APPROVED DRAWINGS HAVE BEEN RED LINED INDICATING A CHANGE TO MEET THE OBC. PLEASE REVIEW ALL PAGES TO ENSURE YOU ARE PROPERLY INFORMED OF CHANGES.

TOWNSHIP OF NORTH DUMFRIES BUILDING DEPARTMENT

These Plans have been examined for Compliance with the Ontario Building Code requirements. A Building Permit has been Issued, subject to any changes noted, under the condition that the building will be constructed in accordance with the code.

Tice River Homes
Legacy

A1

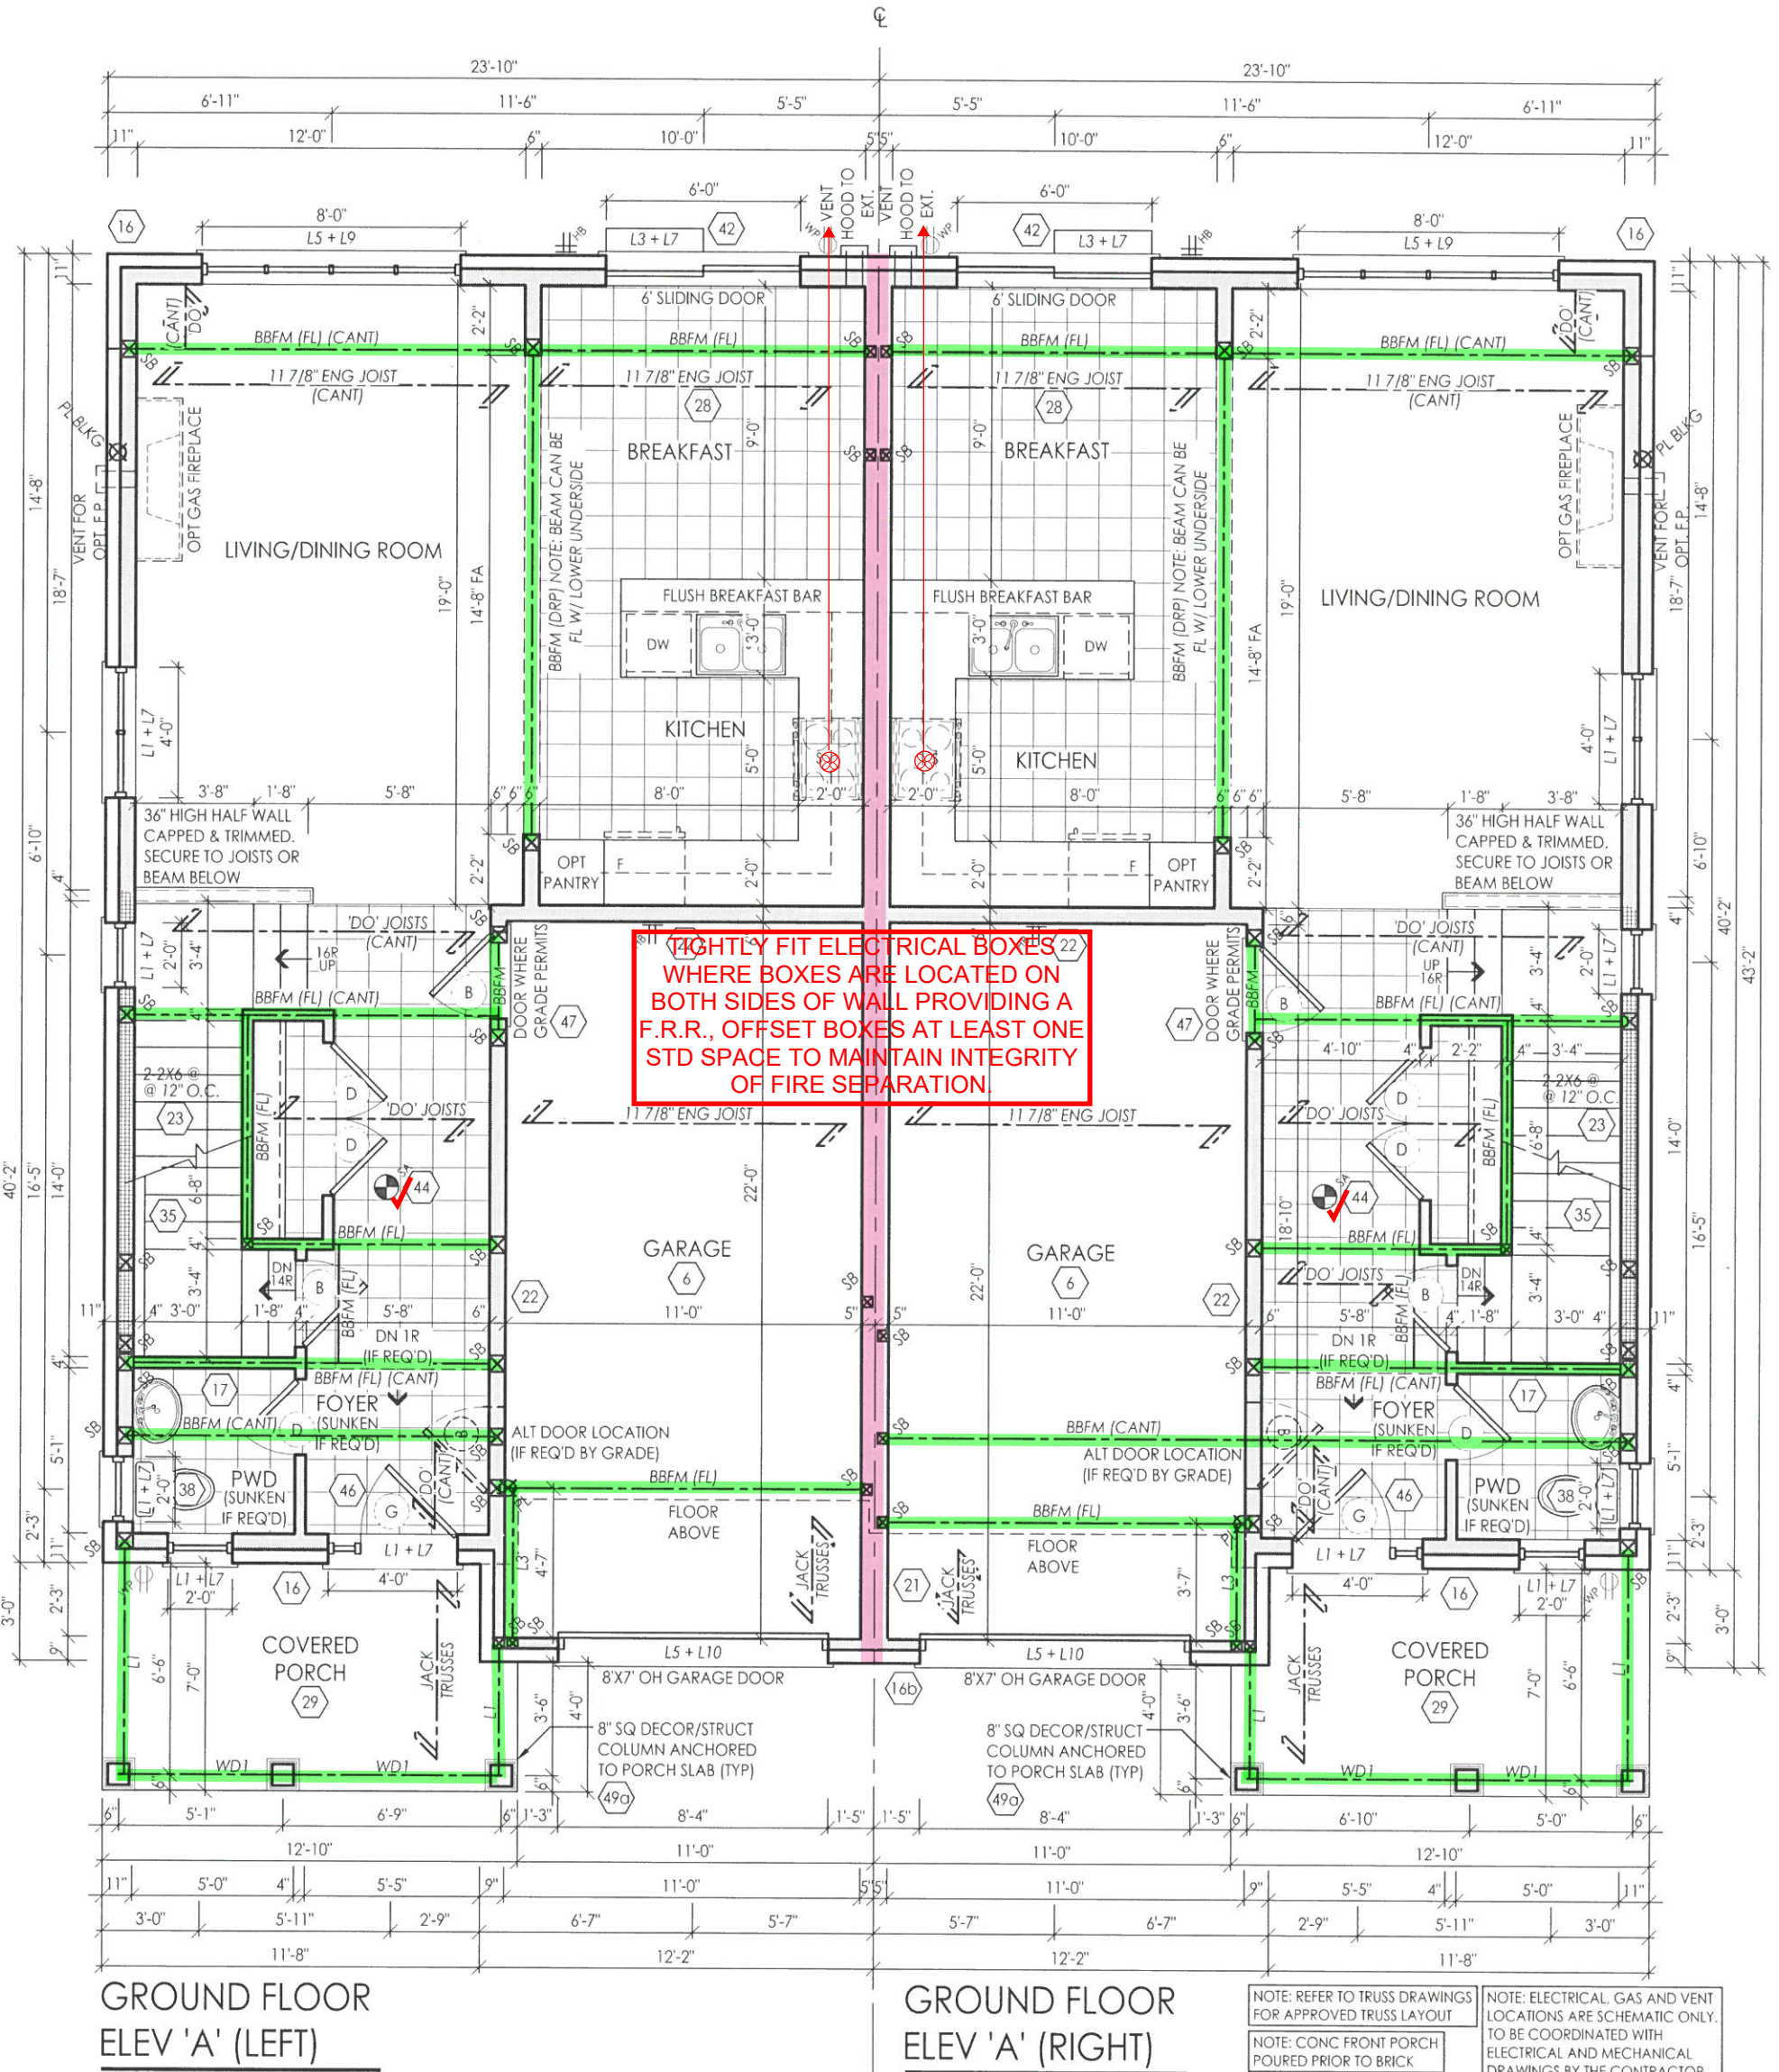
INSULATION IS REQ'D TO BE CONTINUOUS.

A SEPARATE BUILDING PERMIT WILL BE REQUIRED TO FINISH THE BASEMENT.

SUMP PUMP LIDS, JOINTS AT INTERSECTIONS & ALL PENETRATIONS OF SLAB MUST BE SEALED TO PREVENT AIR LEAKAGE.

THE COLD CELLAR DOOR NEEDS TO BE INSULATED AND WEATHER-STRIPPED.

A2

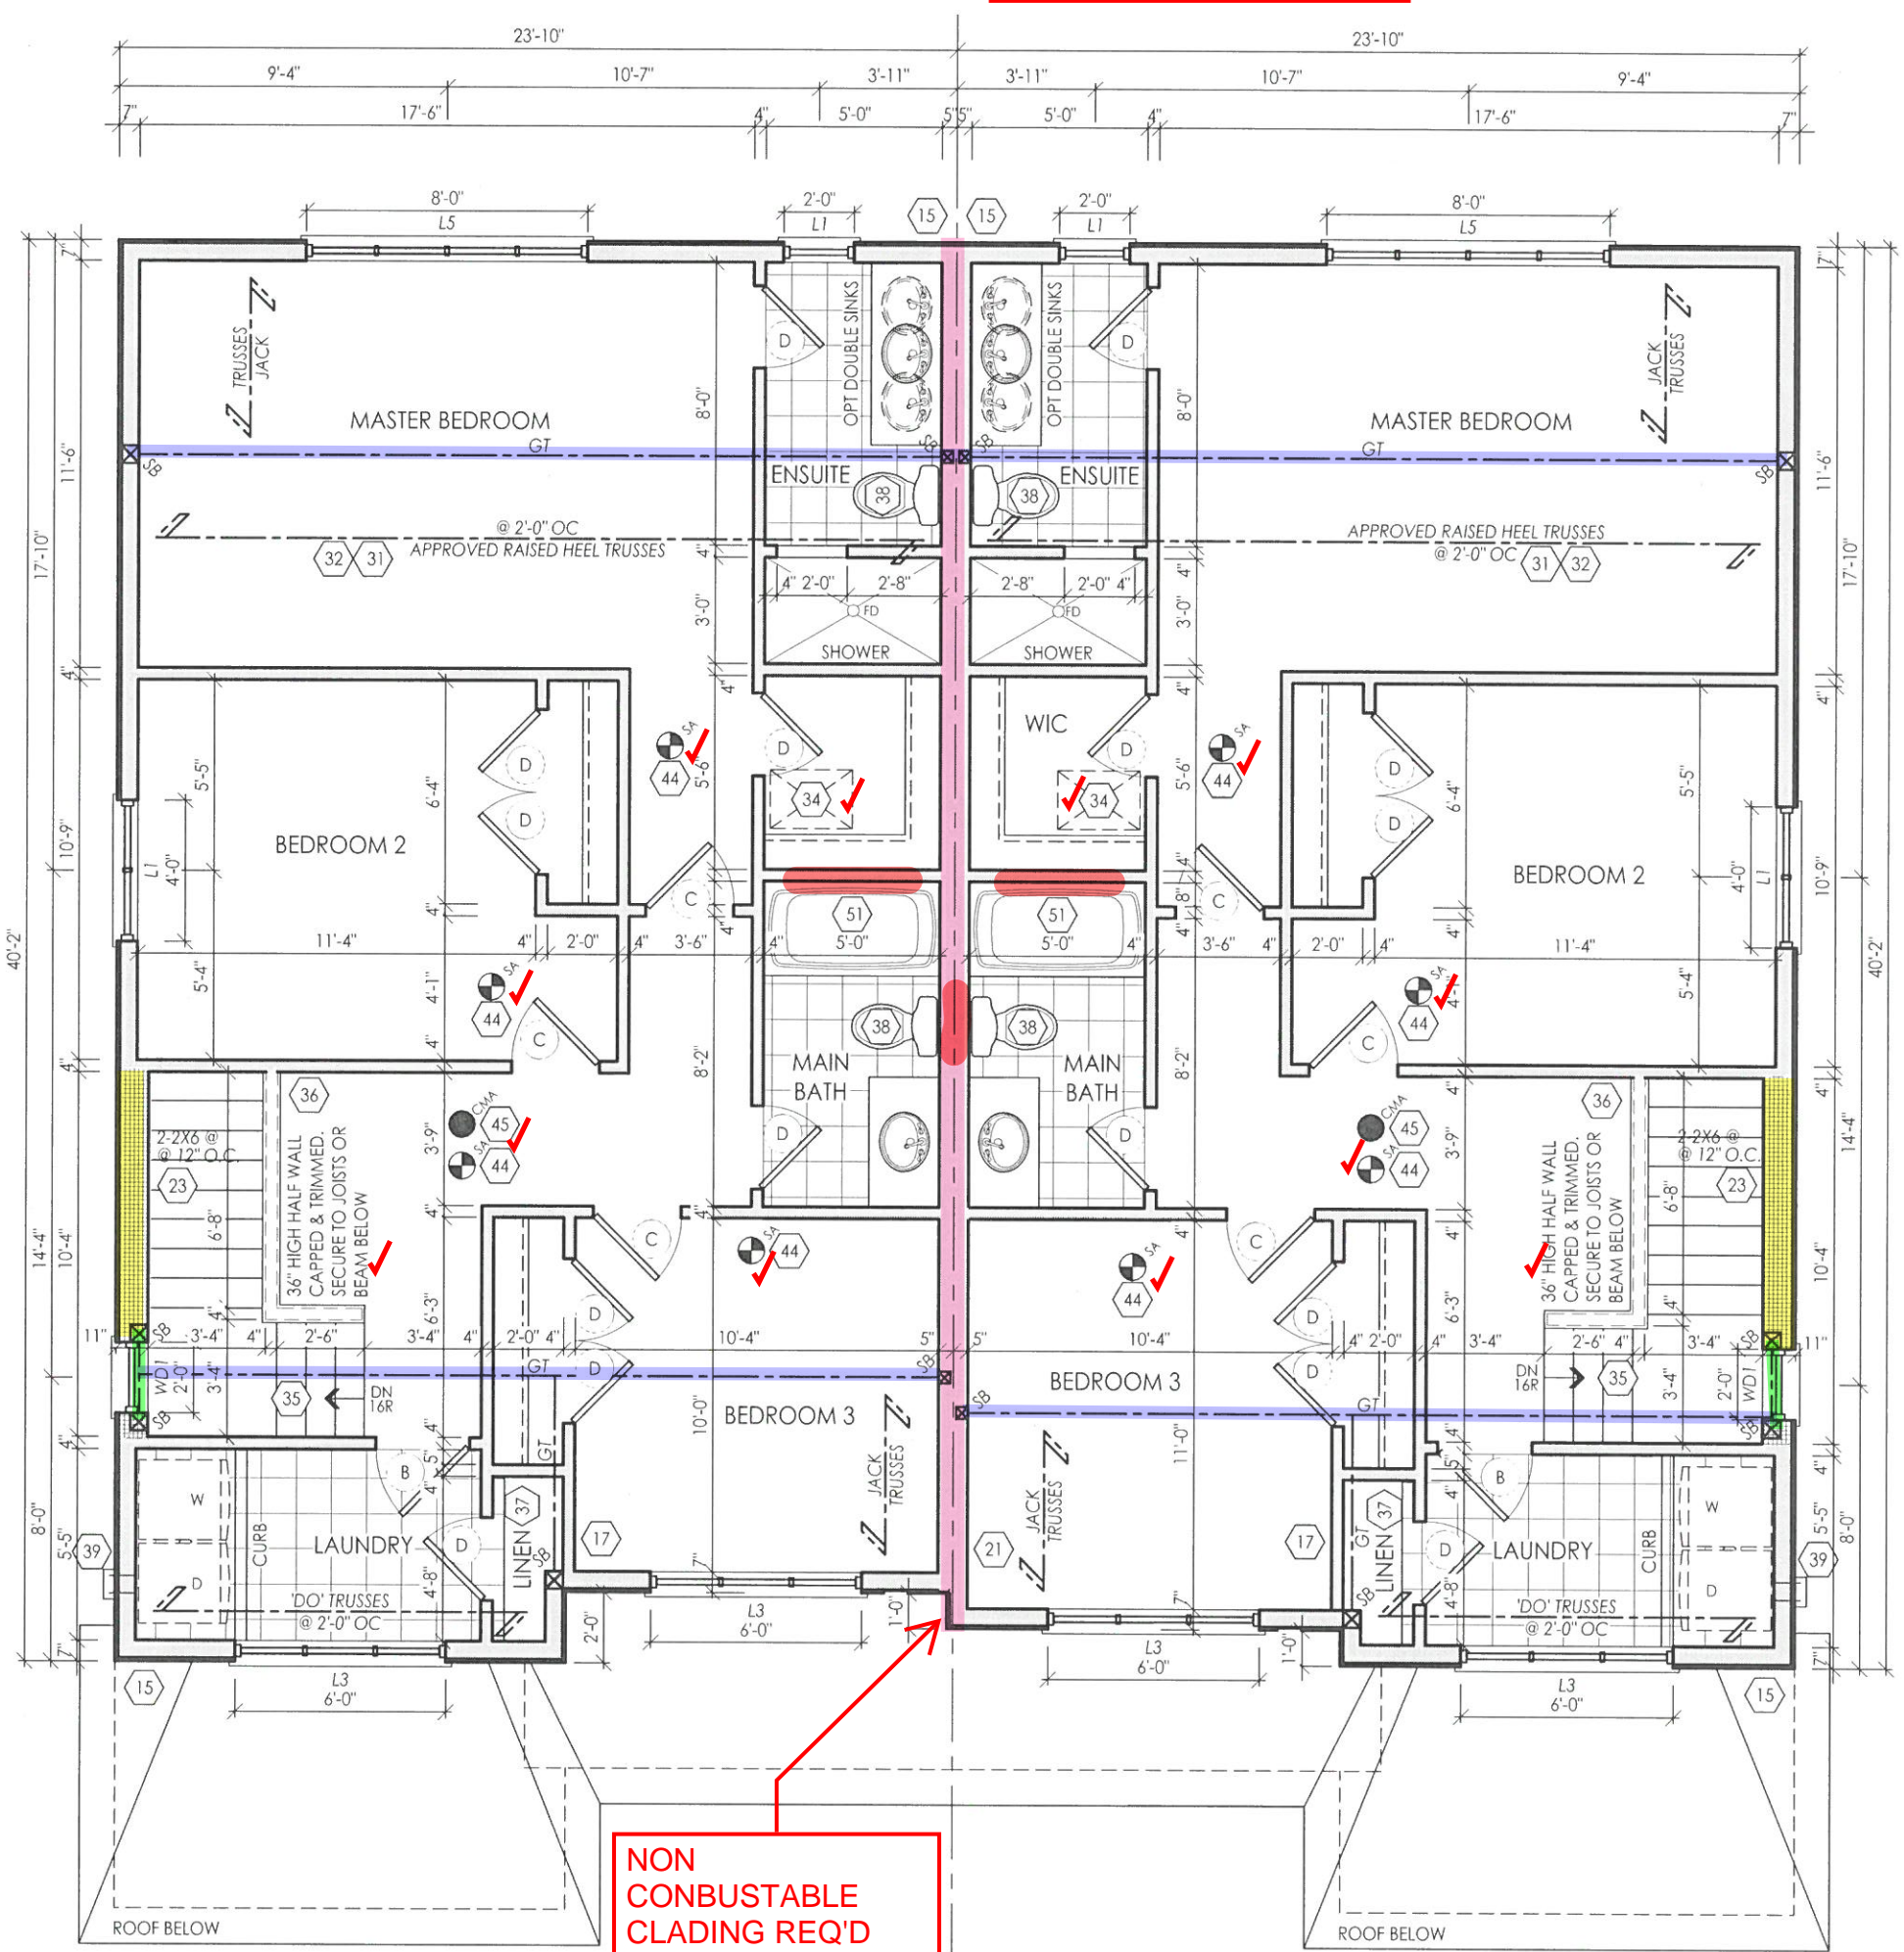
TIGHTLY FIT ELECTRICAL BOXES WHERE BOXES ARE LOCATED ON BOTH SIDES OF WALL PROVIDING A F.R.R., OFFSET BOXES AT LEAST ONE STD SPACE TO MAINTAIN INTEGRITY OF FIRE SEPARATION.

page
A3

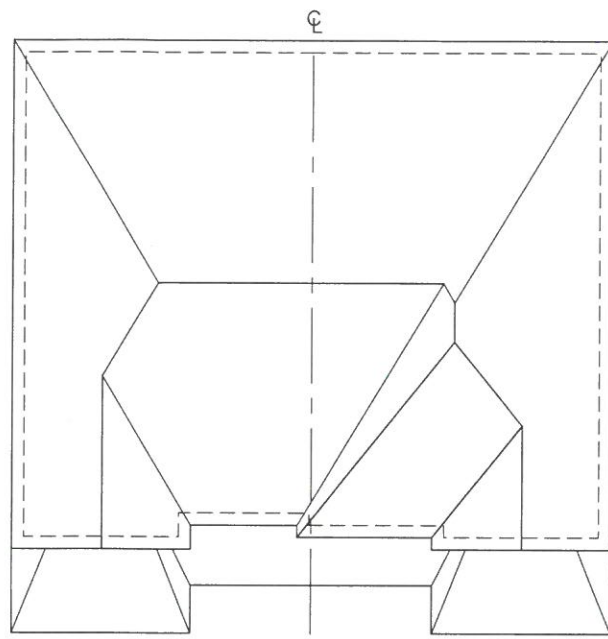
REINFORCEMENT REQUIRED IN MAIN BATHROOM STUD WALLS TO PERMIT THE FUTURE INSTALLATION OF GRAB BARS.

NON CONBUSTABLE CLADING REQ'D
